# Letter Health Consultation

## **Soil Vapor Intrusion Data Evaluation**

LIBERTY INDUSTRIAL FINISHING CORP  
FARMINGDALE, NASSAU COUNTY, NEW YORK

re: Liberty Industrial Finishing Corp.  
Letter Health Consultation  
CERCLIS NO. NYD000337295  
Soil Vapor Intrusion Data Evaluation  
Site # 130005  
Farmingdale, Nassau County

**Figure 1**  
 Sample Location Map  
 Liberty Industrial Site  
 Farmingdale, New York  
 June 2009

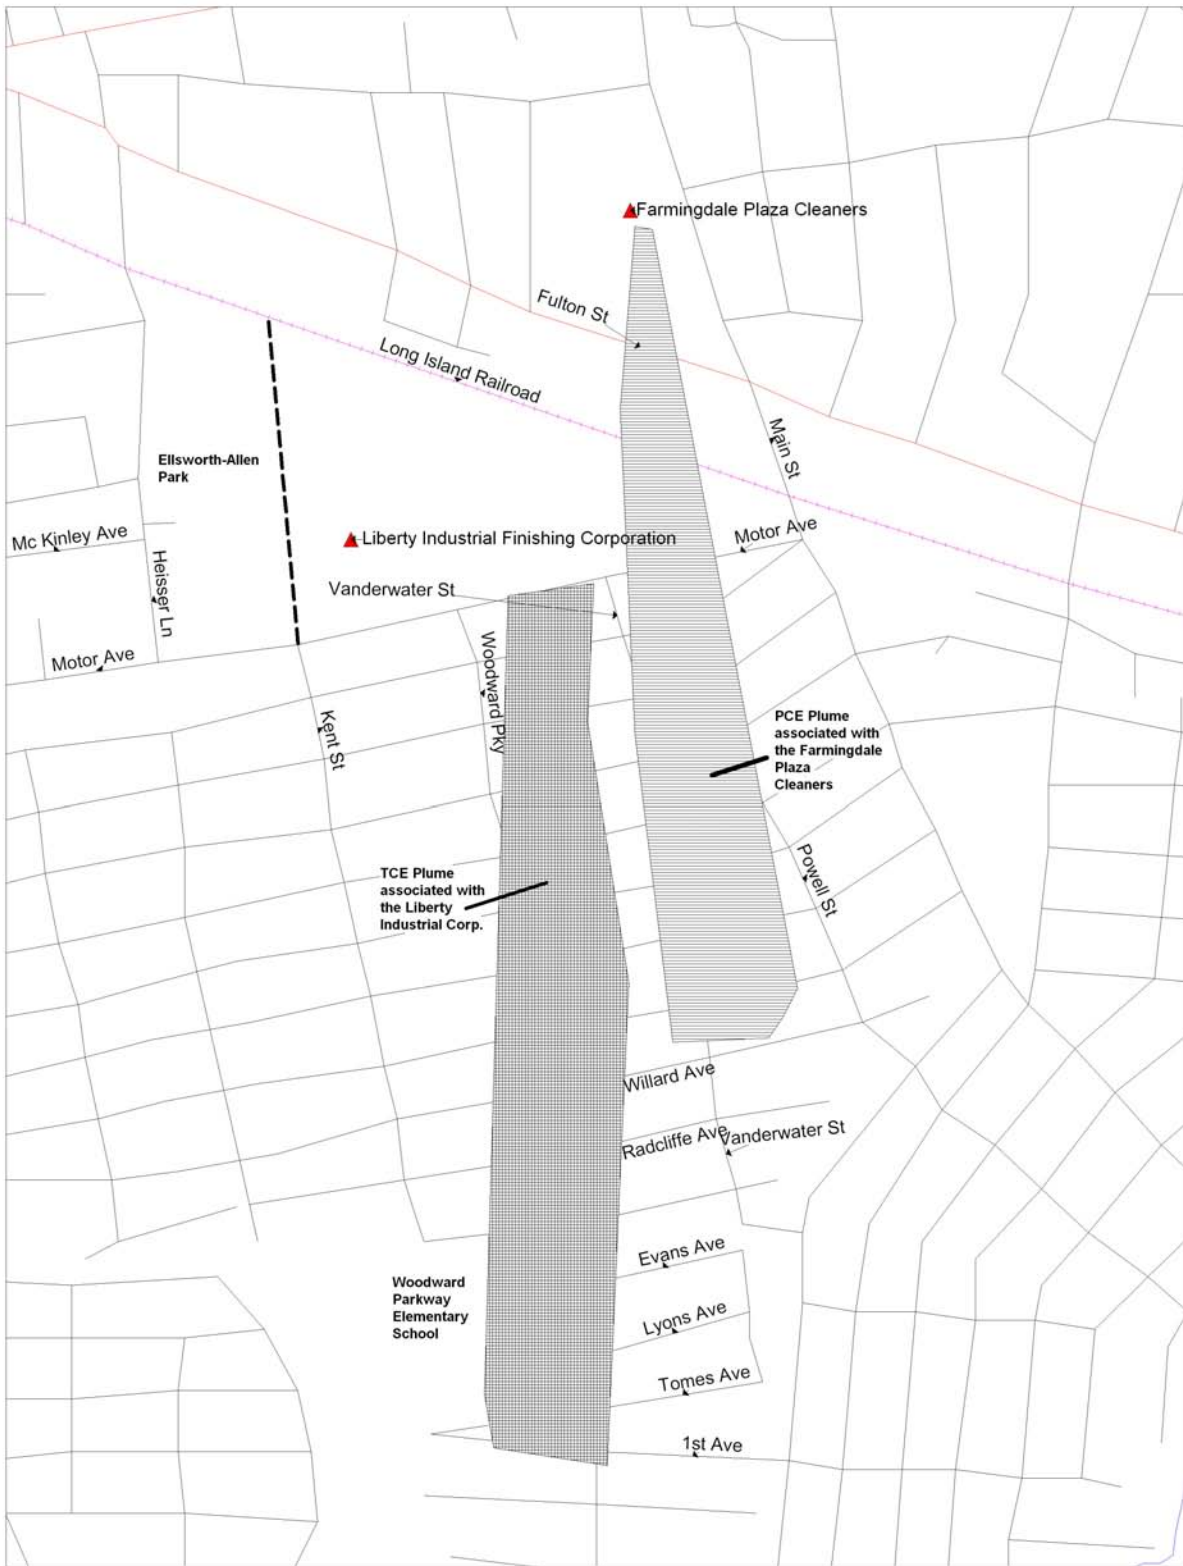
The USEPA conducted right-of way soil vapor and subslab only sampling in 2006, which generated data suggesting a need for further SVI investigations within homes and the Woodward Parkway elementary school located within the path of the site-related TCE plume (Appendix A, Figure 2). The USEPA conducted sub-slab only sampling at several homes and the elementary school. TCE was detected in the sub-slab only data from the 2006 sampling at 3.3 µg/m<sup>3</sup> and at 6.0 µg/m<sup>3</sup> at two residences. While these levels were not extremely high, their detection suggested that the TCE plume may be impacting indoor air quality in down-gradient structures via vapor intrusion. As a result, several SVI sampling events were conducted by the USEPA to determine the potential for vapor intrusion into these buildings (USEPA 2008, 2009).
